# VALIDATION AND VERIFICATION REPORT FOR THE VCS PROJECT: Ningxia Angli Lingwu Photovoltaic Grid Connected Power Plant Project

Document Prepared By China Quality Certification Center (CQC)

<b>Project Title</b>	Ningxia Angli Lingwu Photovoltaic Grid Connected Power Plant Project
<b>Version</b>	2.0
<b>Report ID</b>	VCS-2013-001

Figure 4-1. The connection structure and the meter locations

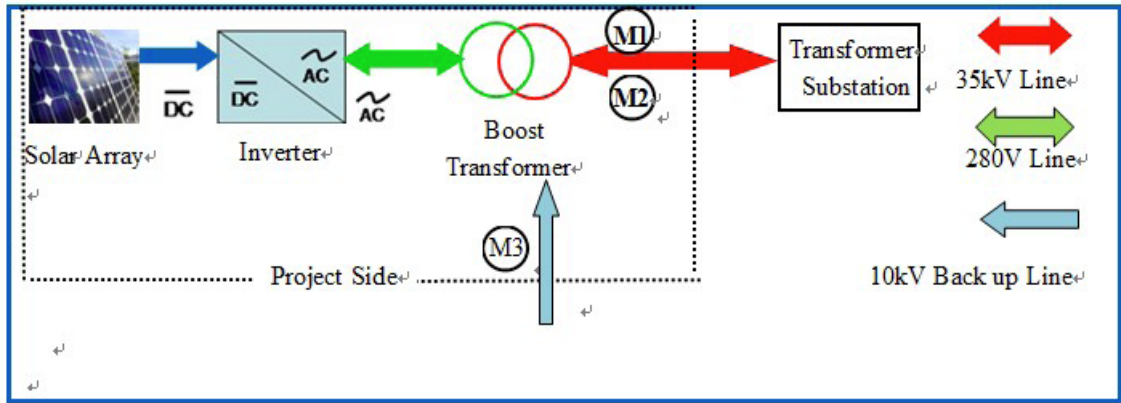
However, the meters which monitor the imported electricity is not fully described in the information of parameters $EG_{grid\ to\ PJ,y}$ in MR version 01, therefore CL1 was raised and successfully closed (Ref to annex 1 of this report for details.).			
	Calibration of the electricity meters was conducted by the accredited third-party organization, Ningxia electric energy metering and Testing Center <sup>16/</sup> . The accreditation certificate number is 3-4-00101-2011. The valid period can cover this monitoring period from 28/12/2011 to 30/11/2012. Calibration certificates <sup>15/</sup> were provided and the calibration was carried out in accordance with the registered PDD. The detailed information on calibration and the two meters are listed below table.			
		Main meter M1	Backup meter M2	10kV meter M3
	Meter Type	DSZ331		DSZ535
	Accuracy class	0.2s		0.5s
	Serial No.	0001468380	0001468381	0001350093

Main meter (M1) and backup meter (M2), which measure the electricity supplied to the grid and electricity supplied by the grid, are installed at the output of the on-site booster station of the project. Meter (M3), which measures the electricity use of power plant supplied by the grid through the 10kV backup line.

Discrepancy findings	Summary of project owner response	Verification conclusion
<p>CL1. The meters which monitor the imported electricity is not fully described in the information of parameters EG<sub>grid to PJ,y</sub> in MR version 01.</p>	<p>The information of 10kV meter, which monitors the imported electricity through 10kV line, has been added in version 02 of MR.</p>	<p>OK. The meters information in MR version 02 is complete.</p>
<p>CL2. The difference between the value of imported electricity in meter readings and sales receipts is not clarified in the MR version 01.</p>	<p>According to the registered PDD, main meter and backup meter are installed at project side which is the source of meter reading. However, as per the agreement between grid company and project owner, the billing meter of exported electricity is the meter installed at the substation of grid side, which is the basis of issued sales receipt. Therefore the only reason about the different value between the meter reading and sales receipts is the line loss when transfer the electricity from the project side to grid site.</p>	<p>OK. The explanation on the difference between the value of imported electricity in meter readings and sales receipts the MR version 02 is reasonable.</p>
